Access Compliance Report

Public Rights-of-Way

Intersection ID: 27337	Main Street: BALLANTYNE_MEADOWS_DR	Cross Street: DUCK_POND_CT	Location: NE
ADA ID: F2E08C4B7C04	Ramp Type: PerpDiag	Initial Pass/Fail: Fail	Overall Compliance: No
Severity Score: 12.5			
Codes/Mitigation Info/Possible Solution		Field Measurements/Component Compliance

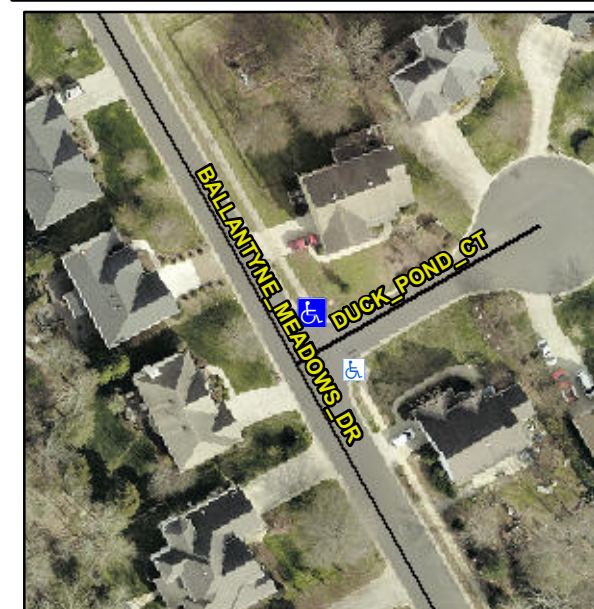
R304.2.2

Compliance	Description	Data	Compliance	Description	Data
N/A	Ramp Length (in)	97.0	No	Ramp Slope (%)	11.9
Yes	Ramp Width (in)	48.0	Yes	Ramp XSlope (%)	1.6
N/A	Flare Type LT	N/A	N/A	Flare Type RT	N/A
N/A	Flare Slope LT (%)	N/A	N/A	Flare Slope RT (%)	N/A
N/A	Flare Traversable LT?	N/A	N/A	Flare Traversable RT?	N/A
N/A	Landing Length (in)	N/A	N/A	DWS Provided?	N/A
N/A	Landing Width (in)	N/A	N/A	DWS Contrast?	N/A
N/A	Landing Slope (%)	N/A	N/A	DWS Length (in)	N/A
N/A	Landing X Slope (%)	N/A	N/A	DWS Full Width?	N/A
N/A	Landing Curb? (Y/N)	N/A	N/A	DWS Offset (in)	N/A
N/A	Shared Landing?	N/A			
N/A	Gutter Ponding?	N/A	N/A	Gutter Slope (%)	N/A
N/A	Gutter Lip Ht (in)	N/A	N/A	Gutter X Slope (%)	N/A
N/A	Painted X Walk1?	No	N/A	Painted X Walk2?	No
	X Walk 1 Direction	To SW		X Walk 2 Direction	To SE
N/A	X Walk 1 Width (in)	N/A	N/A	X Walk 2 Width (in)	N/A
	X Walk 1 Slope (%)	4.2		X Walk 2 Slope (%)	7.5
	X Walk 1 X Slope (%)	5.1		X Walk 2 X Slope (%)	1.9

Remove & Replace Curb Ramp With Two New Directional Ramps or Equivalent.
